**Re: Minor Project Refinement No. 21 for the South Orange County Reliability Enhancement Project.**

## South Orange County Reliability Enhancement Project CPUC Minor Project Refinement Form

**SOCRE PROJECT**  
**MPR-21 Location P322306**  
**San Clemente**  
**Orange County, CA**

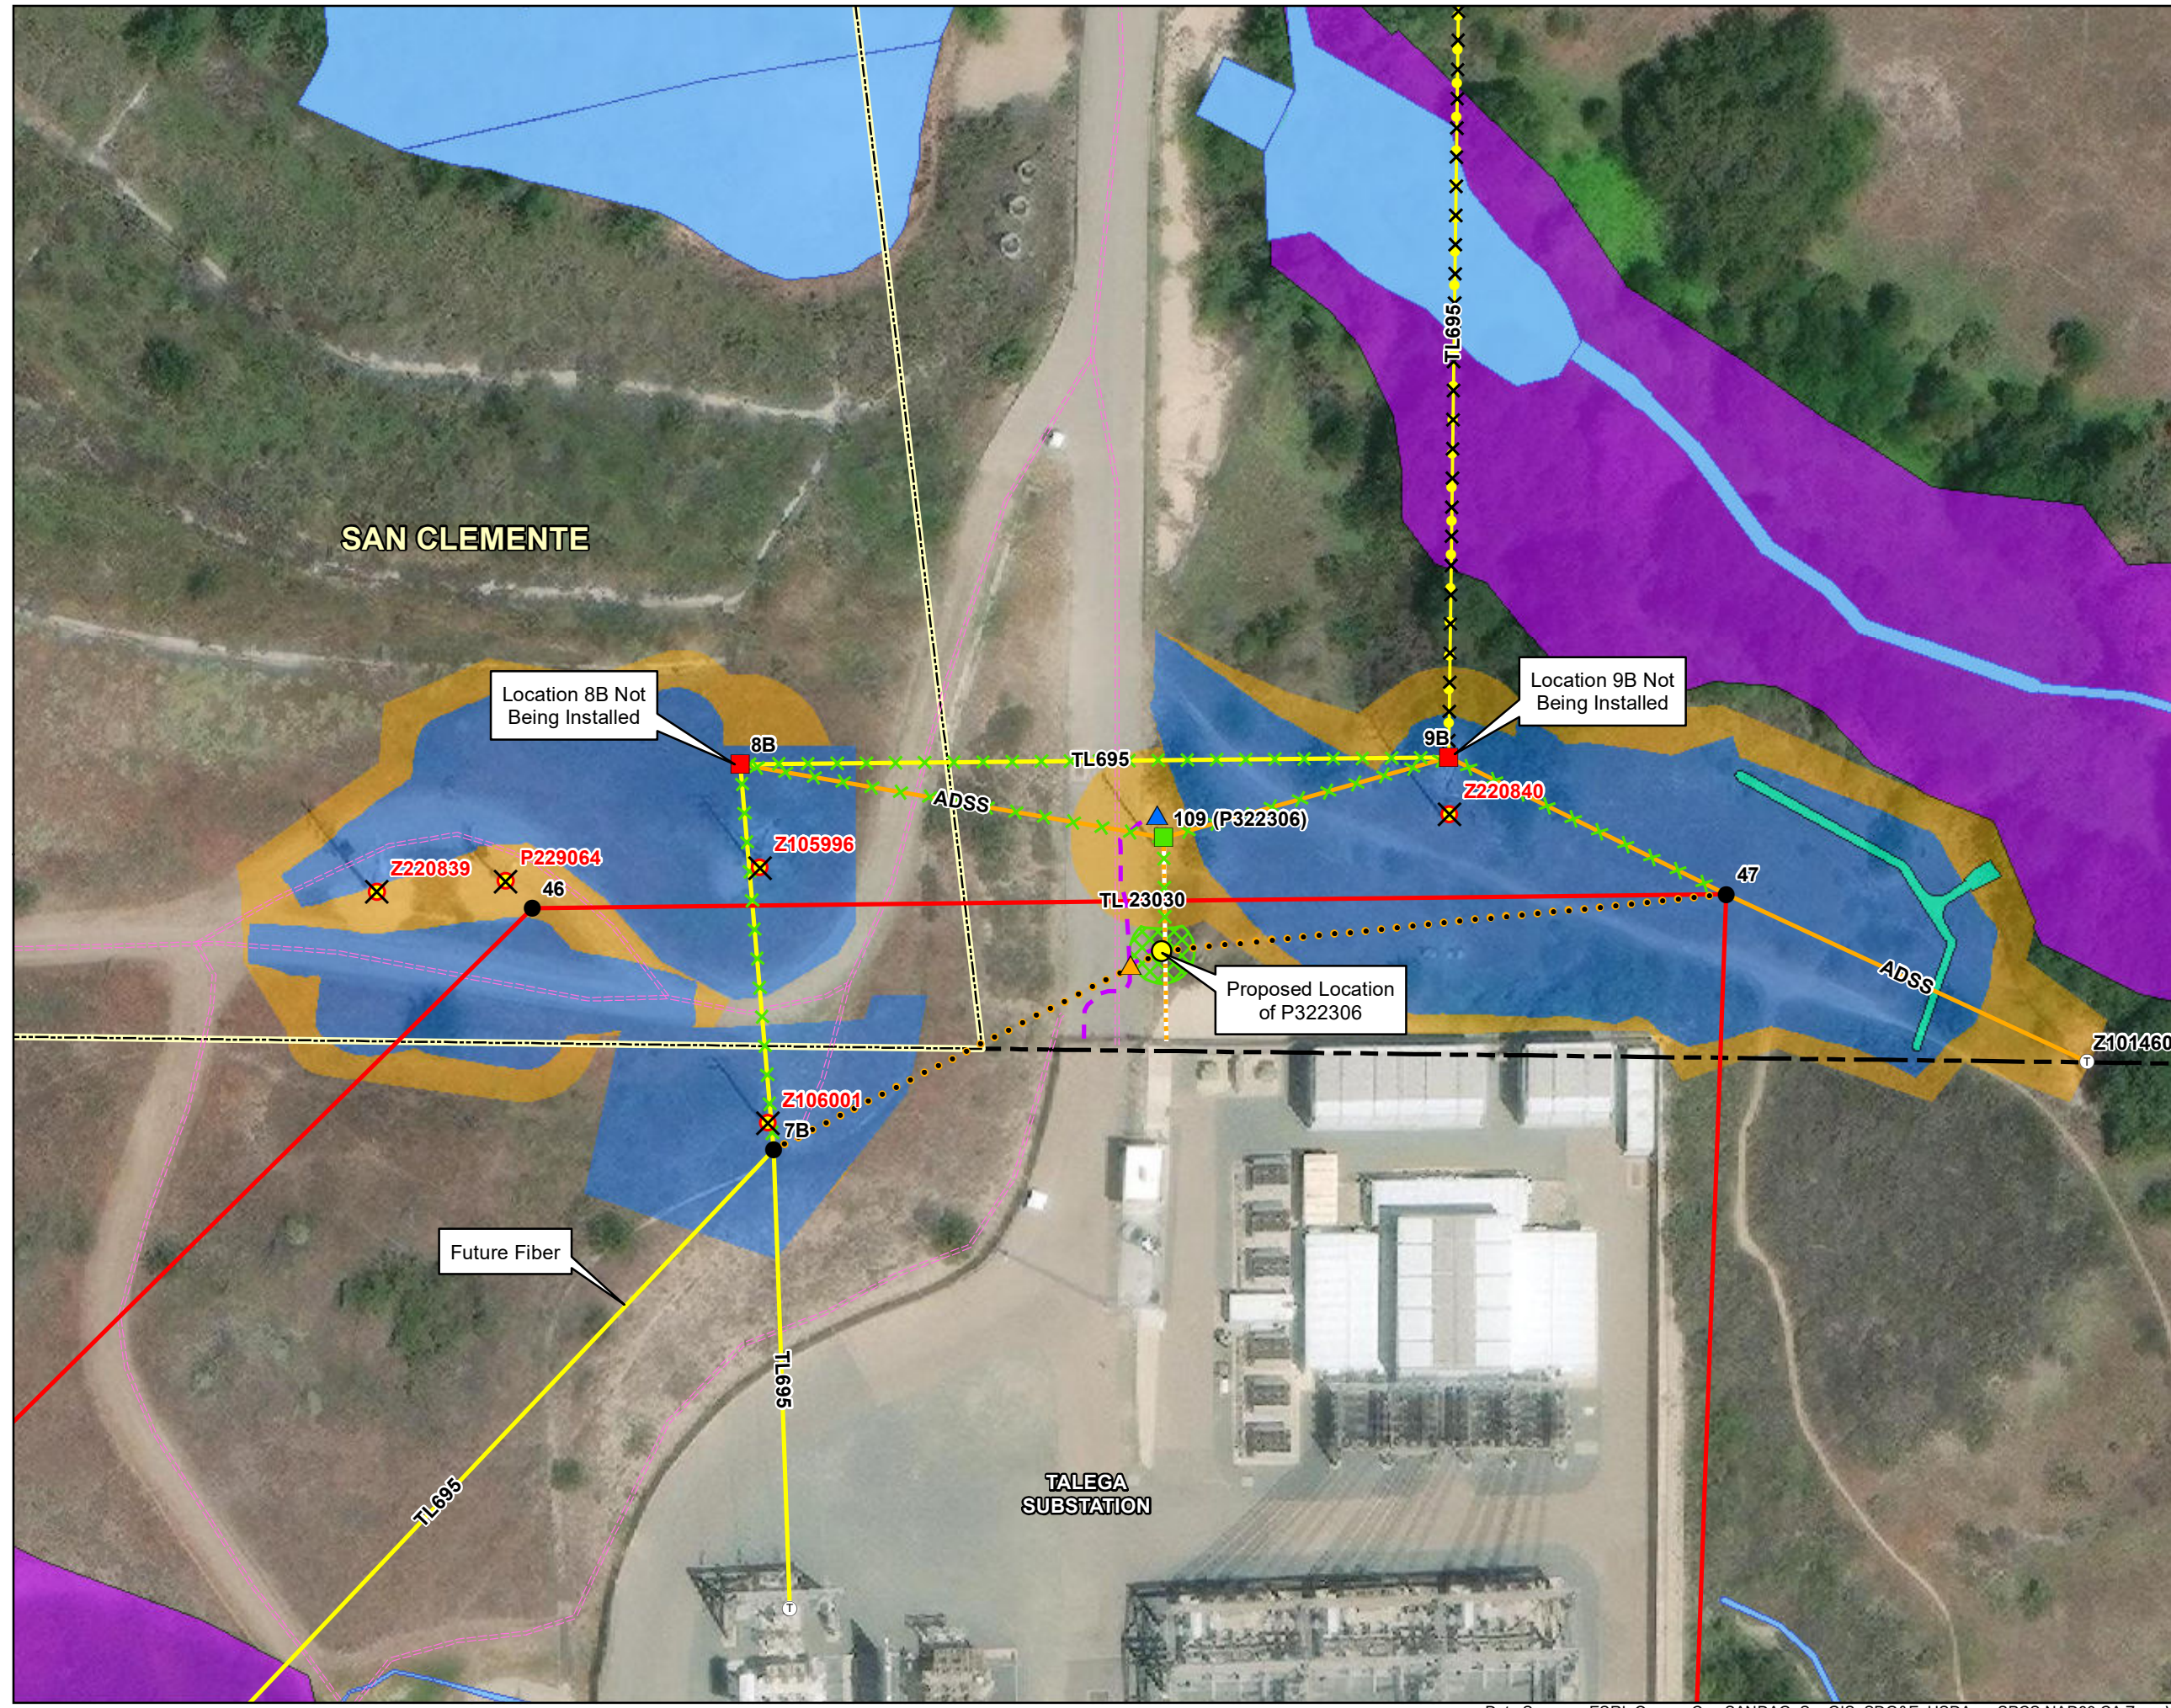
San Diego Gas and Electric (SDG&E) is requesting approval of MPR-21 for the use of a new work area for the South Orange County Reliability Enhancement Project (SOCRE or Project). The new work area is contiguous with previously approved Project components in Notice to Proceed No. 7 (NTP-7) as shown in **Attachment B, MPR-21 Figure**. The new MPR-21 work area will total approximately 290 square feet (0.007 acre).

The MPR-21 work area will be utilized for the repositioning of Location 109 (existing distribution pole P322306) approximately 35 feet south of the existing P322306 location. The MPR-21 work scope includes the installation of a new handhole within the paved road located west of the new pole location. The original scope for P322306 consisted of overhead work on the existing P322306 pole and potential underground work for maintenance of the All-dielectric Self-supporting (ADSS)

Final engineering has eliminated the need for the installation of Locations 8B and 9B, therefore, the proposed overhead alignment for the ADSS communications cable will extend between Z294103 within Location 47 to the new P322306 location prior to being undergrounded in the new handhole located within the road west of the new P322306 location. Future fiber will come in from the west and connect Z120029 in Location 7B to the new P322306 replacement location. Overhead work already accounted for in NTP-7 will take place at Locations 47 and 7B utilizing bucket trucks staged within the existing maintenance pads and access roads to accommodate this adjustment.

Justification for Change: Following final engineering and constructability review in the field, it was determined that Locations 8B and 9B no longer needed to be installed as part of the Project. As a result, reconfiguration of the overhead alignment for TL695 and TL23030 was required. This reconfiguration has necessitated an adjustment of the overhead ADSS communications cable. The relocation of P322306 35 feet south is therefore being proposed which results in a safer overhead configuration that reduces overlap of energized wire between the existing TL23030 line and the overhead ADSS communications cable. If the existing P322306 pole were to remain in place, the proposed overhead ADSS communications cable would cross underneath the overhead 230-kilovolt (kV) line (TL23030) in two separate areas between Locations 7B and 47, posing an increased safety risk. A new handhole is required west of the new P322306 location. Trenching will be required through the paved road north of the Talega Substation to the new handhole location, as well as from the new handhole location to the existing handhole located north of the existing P322306 location. This trenched pathway is required in order to implement the underground connection requirements.

- COA-1. The extent of the MPR-21 disturbance areas will be limited to the areas shown on the figure titled "SOCRE PROJECT MPR-21 Location P322306" and will only be used for project related construction activities during the period of project construction and restoration (anticipated to be approximately through the first quarter of 2025).
